REGULATORY INFORMATION DISTRIBUTION SYSTEM (RIDS)

SUBJECT: Forwards responses to Geosciences Branch Questions 360.14 & 360.17. Faults along Rattlesnake-Wallula alignment are not capable according to NRC criteria. Estimates of potential earthquake magnitudes encl.

Subject: NUCLEAR PROJECT NO. 2
RESPONSES TO REQUESTS FOR INFORMATION

Q. 360.014

Figure
360.14-1

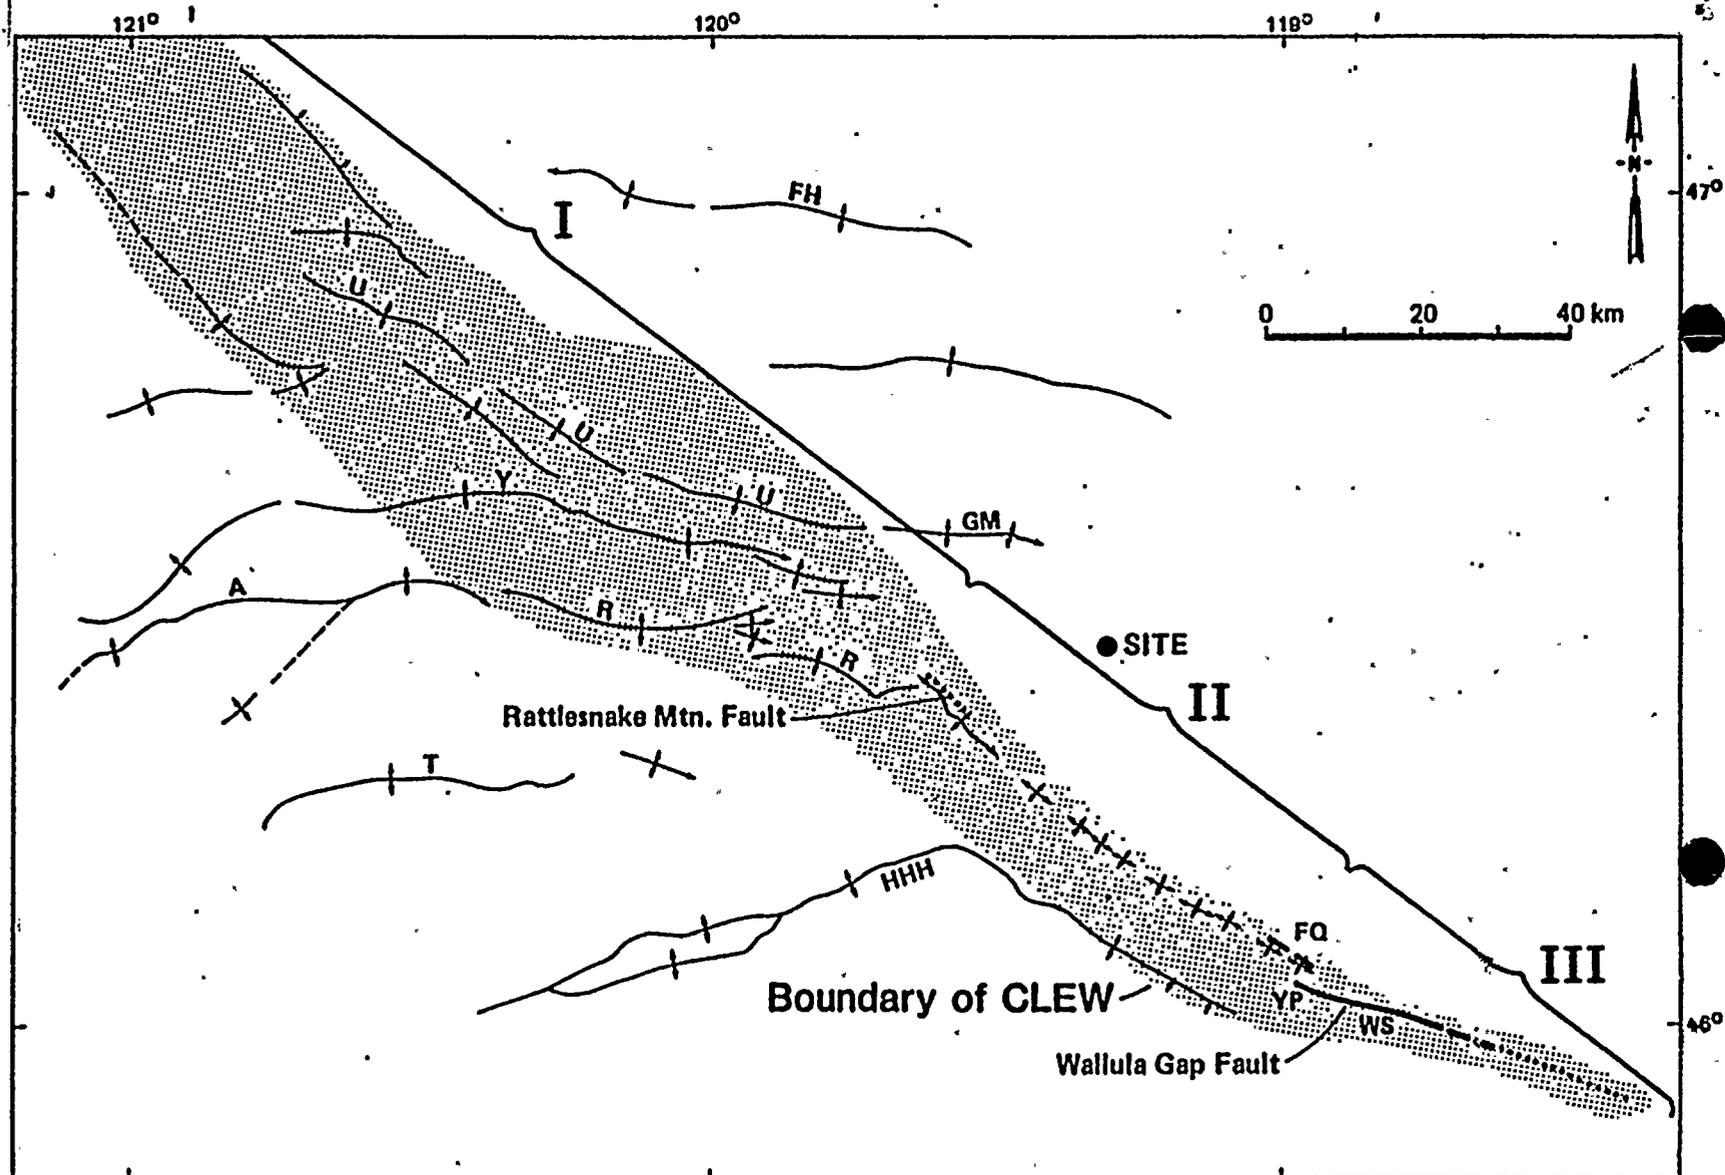
Provide your best deterministic judgement of the length, character, and capability of CLEW within the site region. If you determine it to be segmented as reported in the meeting of November 17-18, 1981, provide a map with topographic base delineating the segments and discuss in detail the character and capability of the individual segments, with supporting basis for all judgements.

The Cle Elum-Wallula lineament (CLEW), as defined by Laubscher (Appendix 2.5-0), is a 240 km-long northwest-trending zone of "en echelon" anticlines that includes part of the Yakima fold belt (Figure 360.014-1). CLEW is coincident with the central third of the Olympic-Wallowa lineament (OWL) which was postulated by Raisz (1945). The portion of CLEW that extends from Rattlesnake Mountain southeastward to the vicinity of Milton-Freewater has been termed the Rattlesnake-Wallula alignment (RAW) (Appendix 2.5K).

Davis (Appendix 2.5N) defines three structural domains of CLEW (Figure 360.014-1); domains II and III comprise RAW. Domain I extends south from Cle Elem to Rattlesnake Mountain and is defined by a broad zone of deflected or anomalous fold trends. Although Davis included Rattlesnake Mountain in domain I, the Rattlesnake Mountain anticline is similar in structural style and orientation to the doubly-plunging anticlines of domain II. Therefore, the Rattlesnake Mountain anticline has been included in domain II in this analysis.

Map of the Cle Elum-Wallula Lineament (CLEW) showing structural domains I, II, and III. The Rattlesnake-Wallula alignment (RAW) is comprised of domains II and III. Names of anticlinal ridges are: A, Ahtanum Ridge; FH, Frenchman Hills; GM, Gable Mountain; HHH, Horse Heaven Hills; R, Rattlesnake Hills; SM, Saddle Mountains; T, Toppenish Ridge; U, Umtanum Ridge; Y, Yakima Ridge. Localities along RAW are: FO, Finley Quarry; YP, Yellepit; WS, Warm Springs.

FIGURE 6

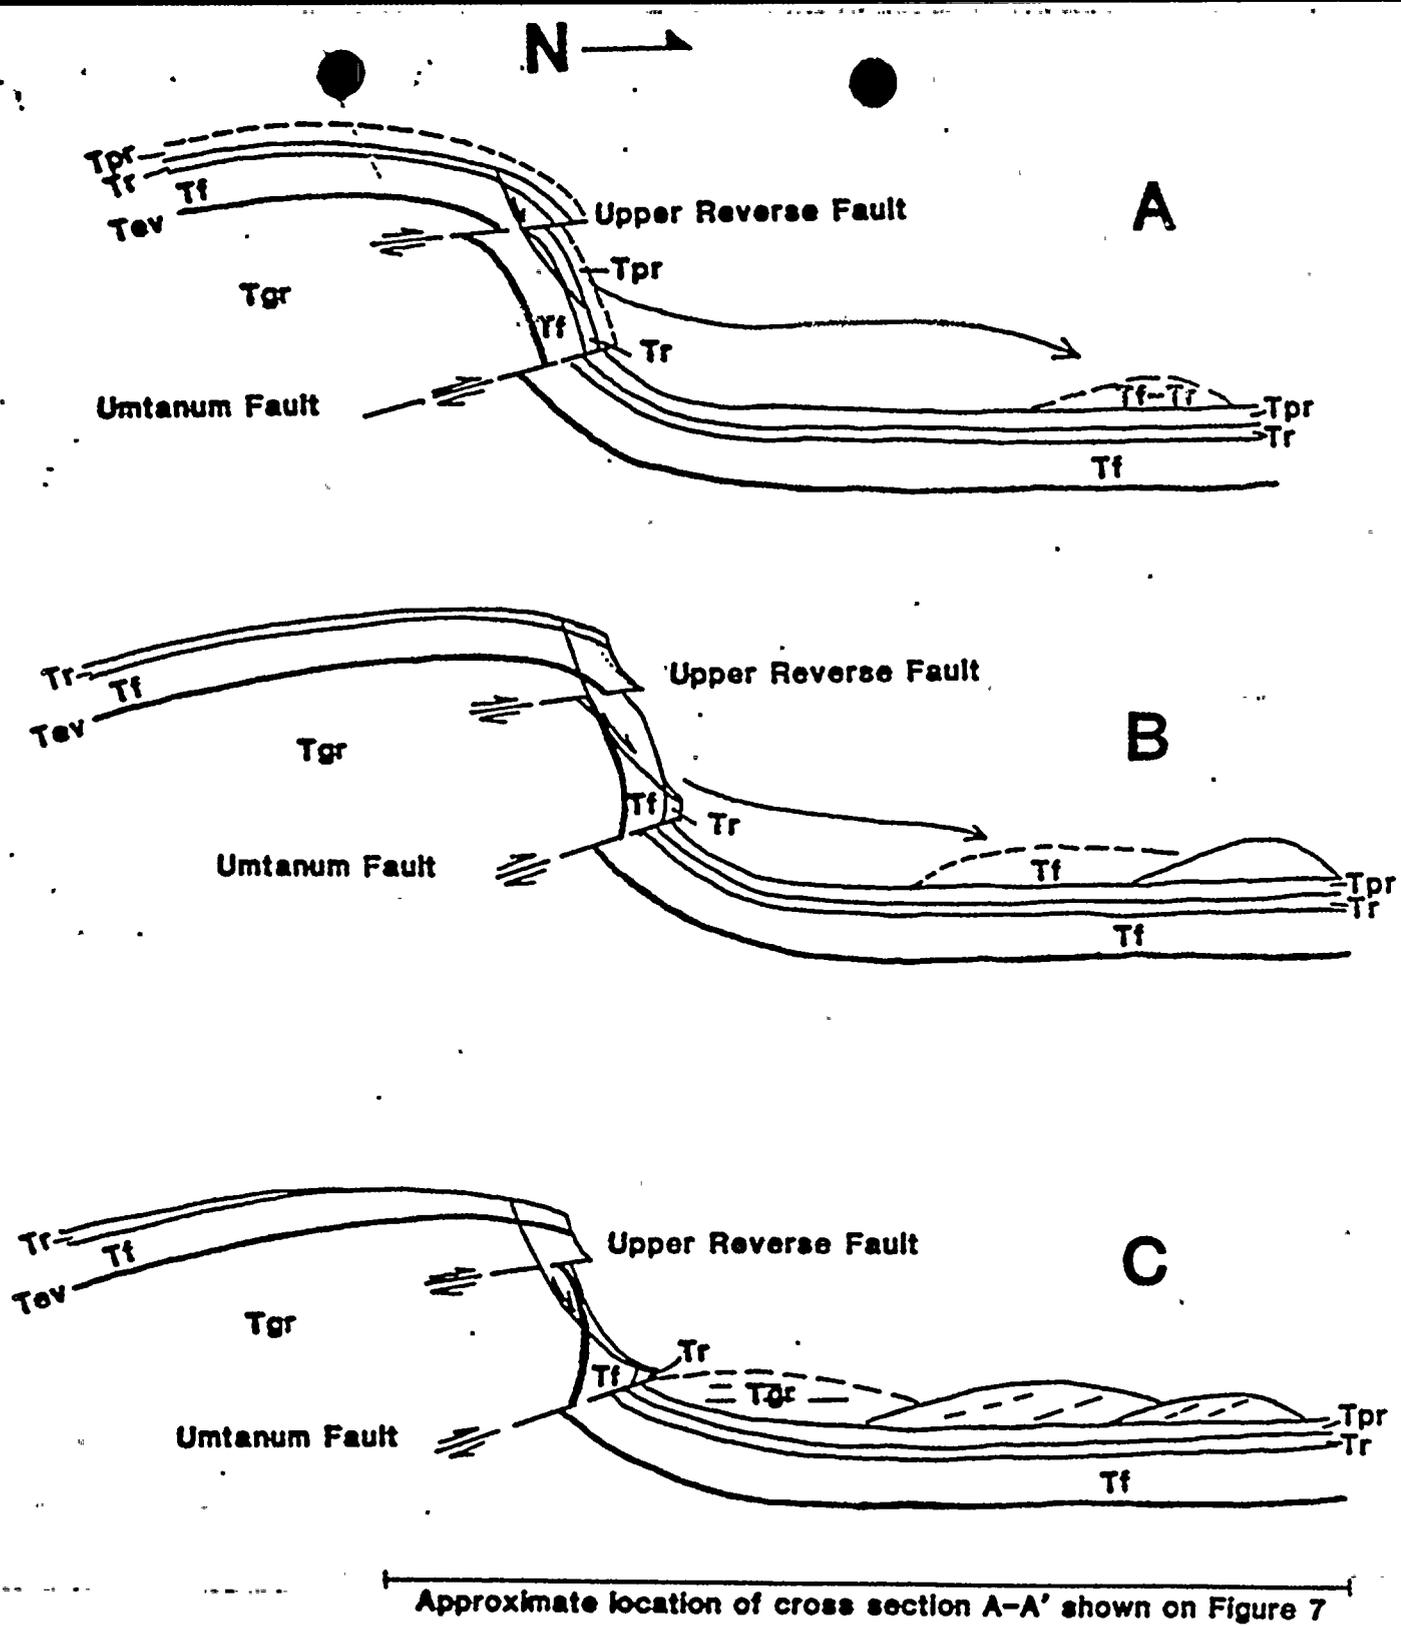
In the section on Umtanum Ridge - Gable Mountain, reference was made to the Golder report to NESCO. Reevaluate the structural and/or tectonic model on Umtanum Ridge in light of the geologic map and cross section of the Golder report (Figure 2N-11, 2N-13) suggesting normal faulting on Umtanum where reverse arrows are shown. (Contact Tim Hait, USGS.)

Another model involves northward sliding of very large landslide blocks off the uplifted crest of Umtanum Ridge fold (Figures 6 and 7). In this model, the most northerly fault (the north reverse fault) is at the toe of the large, lobate rock mass

of older Wanapum and Grande Ronde Basalt which is interpreted as a landslide complex in this model. Figure 8 is a sketch of the structural configuration of the eastern segment of Umtanum Ridge between Sourdough Canyon and Priest Rapids Dam. The Twin fault is considered to be a tear fault across which differential folding of the ridge front occurred. Units to the west of this fault are more tightly folded and overturned than units to the east. The upper reverse fault is a low angle thrust in the hinge area of the fold where units in the upper limb overrode units in the steeply dipping northern limb. The upper reverse fault resembles the Buck thrust of Price (1981a) in this respect. Periodic oversteepening of the fold and associated landsliding could account for the complex lobate rock mass which now lies to the north of what is shown as the Umtanum fault on Figure 1.
